City Commission
June 3, 2008

Gables Waterway

The Planning Department based upon the complete findings of fact contained within the Staff report recommends denial of the five (5) applications referred to as “Gables Waterway”  
(pg 2)

## 2. Incompatible transition of massing (pgs 15-18)

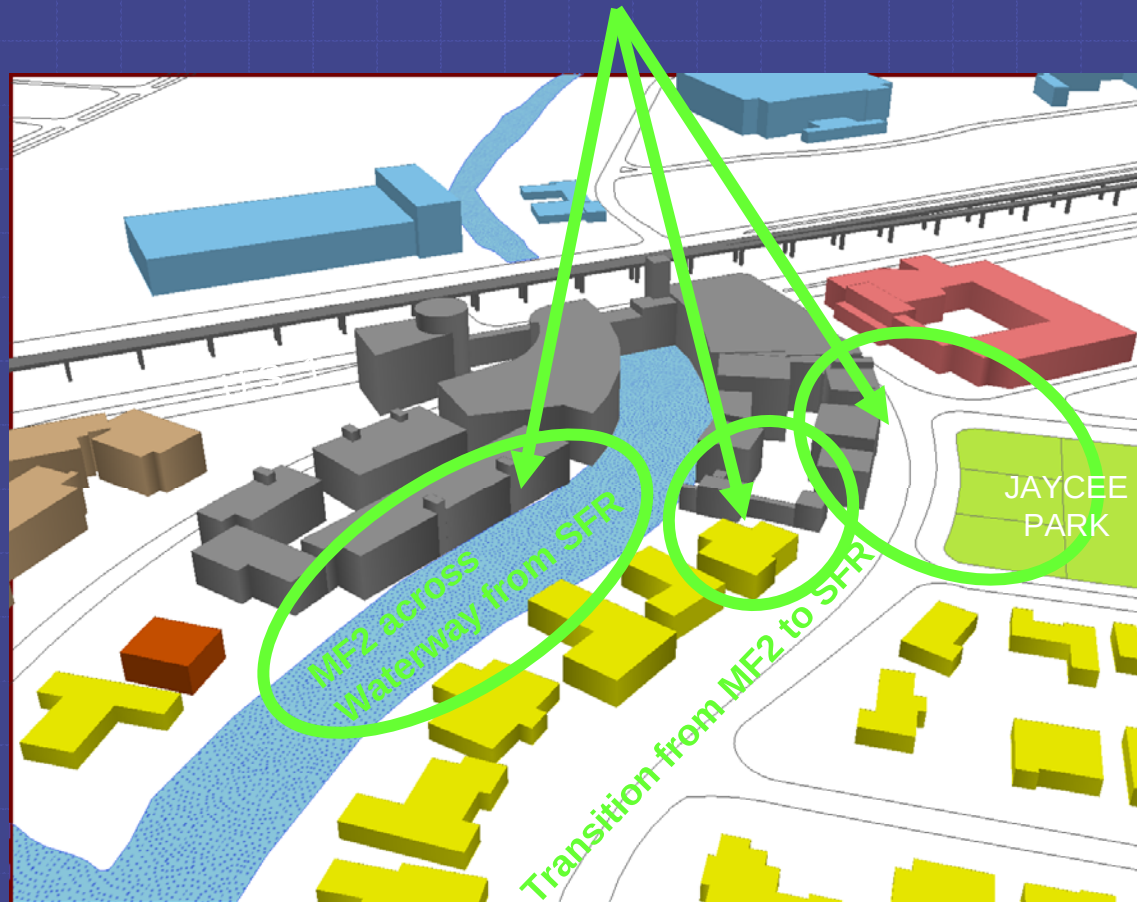
- Project does not provide adequate **transition of massing**
- Project does not provide adequate transition in **height and scale** from U.S.1 back to the existing single-family and duplex uses
- 5 story height of residential building across from **Jaycee Park**, and proposed reduction of both the required **front and rear setback** of the project's multi-family residential structures would impact adjoining properties and single-family residences located across the canal

## Comparison of Allowed/Existing and Proposed Development

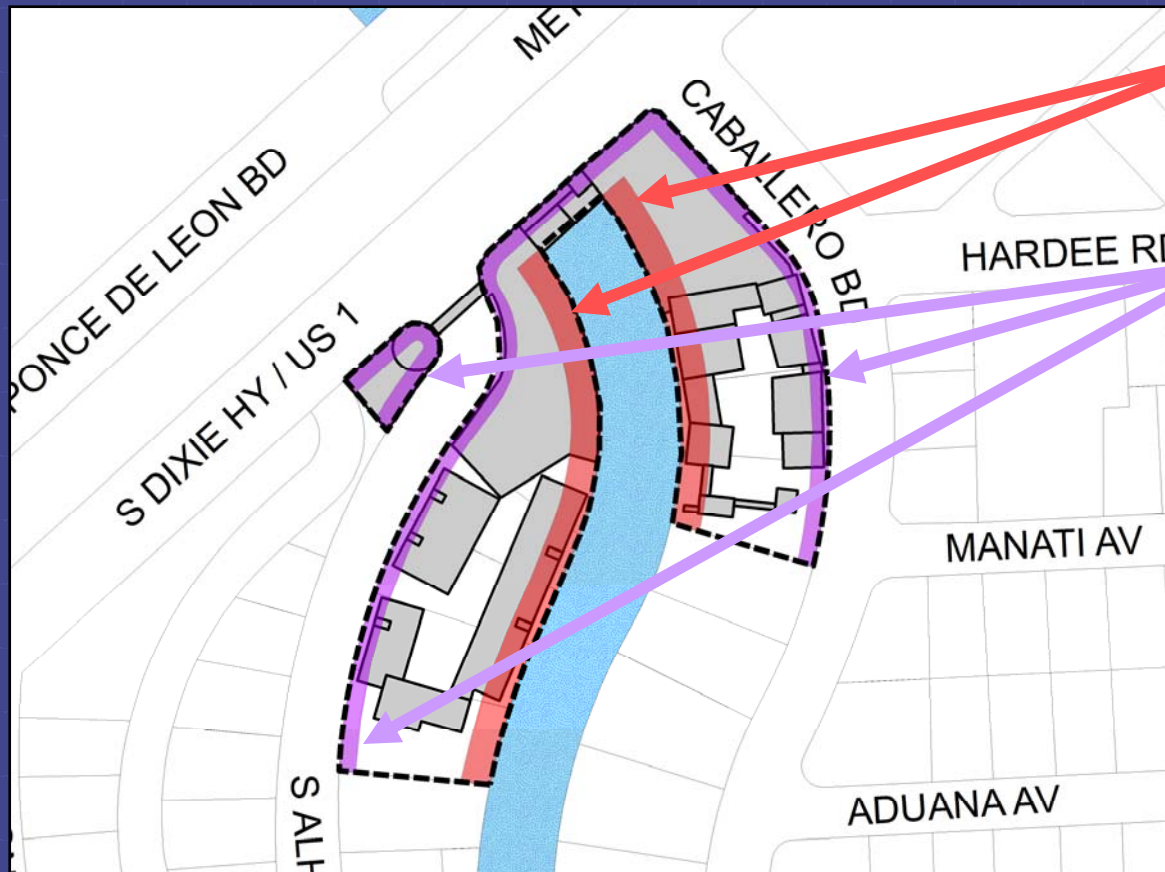
- Project's size and density are **inconsistent with scale and character** of the surrounding neighborhood
- Applicant's proposed mitigation **does not support the award of requested site development bonuses**
- Proposed project with bonuses (setback relief, building height and additional residential units) results in increased project size, loss of open space and existing tree canopy, and insufficient transition and buffering between uses which are **inconsistent with the scale and character of the surrounding neighborhood**
- Would **encourage further incompatible redevelopment**
- Preliminary Zoning Analysis indicates the 20% on-site landscape open space required for a PAD has not been met and the **applicant requires credit for off-site landscaping**

| <i>Category</i>                | <i>Currently allowed as-of-right</i>                                                       | <i>Proposed PAD and commercial building</i>                                        | <i>Change</i>                                                  |
|--------------------------------|--------------------------------------------------------------------------------------------|------------------------------------------------------------------------------------|----------------------------------------------------------------|
| Multi-family residential units | 22 units                                                                                   | 95 multi-family units (99 units permitted w/ architectural bonuses)                | <b>+ 73 multi-family units</b>                                 |
| Total development (sq. ft/FAR) | Maximum 279,186 sq. ft./ 1.3 FAR (likely limited by various regs (setbacks, parking, etc.) | 279,443 sq. ft./1.3 FAR (up to 528,992 sq. ft. permitted w/ architectural bonuses) | + 257 sq. ft. <b>(proposal permits up to +249,806 sq. ft.)</b> |

| <i>Category</i>                        | <i>Required</i>              | <i>Provided</i>                   | <i>Variance</i>     |
|----------------------------------------|------------------------------|-----------------------------------|---------------------|
| On-site landscaping                    | 40,070 sq. ft. (20% of site) | 39,398 sq. ft.                    | <b>-672 sq. ft.</b> |
| Setbacks*:<br>Front<br>Rear (waterway) | 17-25 ft.<br>35 ft.          | <b>0-10 ft.</b><br><b>0-6 ft.</b> | varies<br>varies    |

## 6. Project phasing (pgs 26-32)

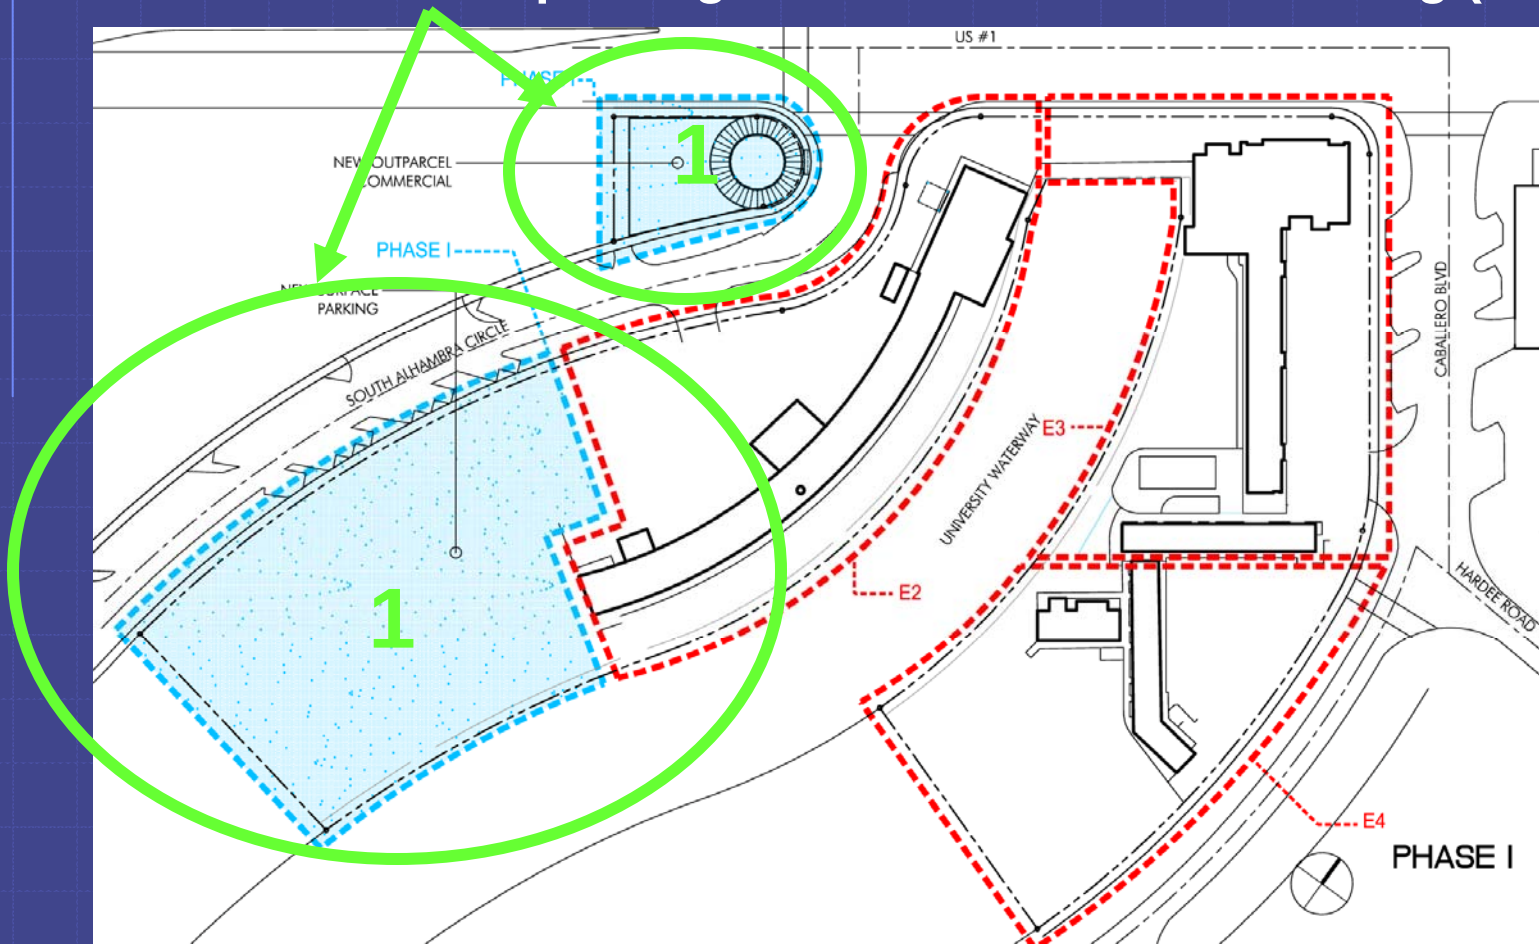
- Project is proposed to be developed in various phases, which if left unplanned and/or unchecked, could result in significant **impacts to the surrounding neighborhood**
- **No assurances provided** that the project fulfills the PAD objectives and purpose if the project is not built-out and all proposed phases constructed
- A **projected timeline is necessary** for each phase of the project and for the build-out of the entire project
- No proposed use of **proposed interim surface parking lot** or plan has been submitted providing details showing vehicular entrances, paving/curbing, landscaping, lighting and pedestrian circulation

## Lack of marina facilities operation plan

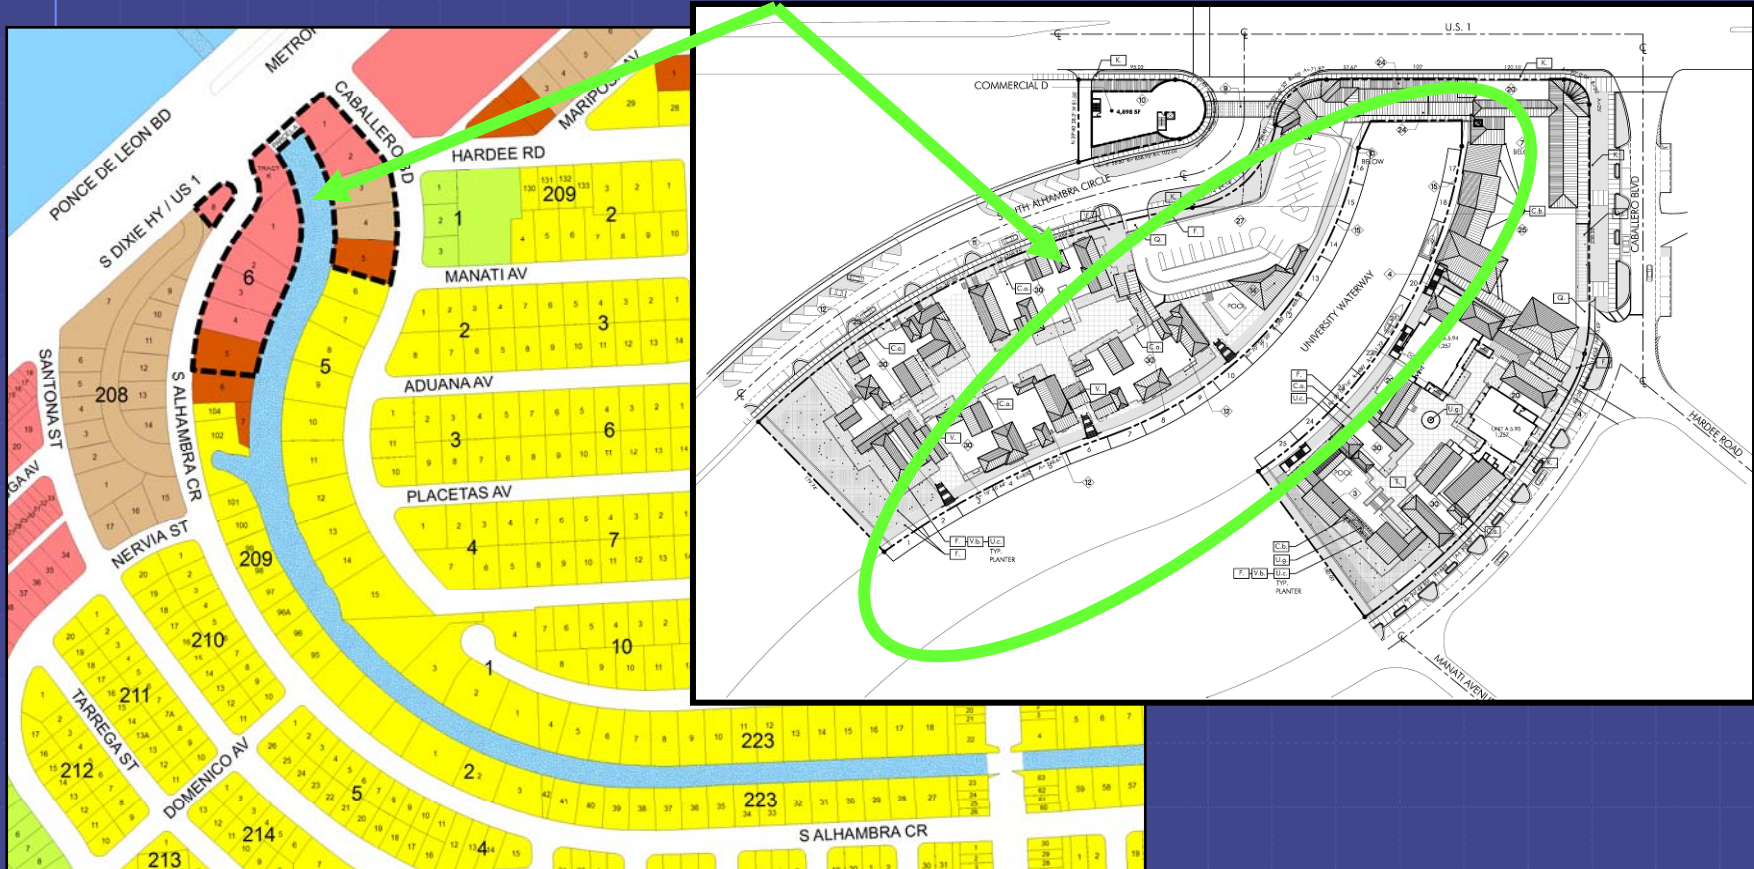
- Project will result in **increased use of existing marina** situated along **ecologically sensitive canal habitat**, which, if left unmanaged, could negatively impact the canal and surrounding single-family residential neighborhood
- **No operational plan provided** for the renovation and use of the existing 25 boat berths that are proposed to be assigned to owners of new residential units
- Marina is located at the end of a canal utilized primarily by the existing single-family residential neighborhood through which the canal courses, and serves as an environmentally sensitive manatee habitat
- Application **does not sufficiently address the servicing of vessels** at the marina to ensure there is minimal impact on the surrounding residential neighborhood and existing manatee habitat along the waterway
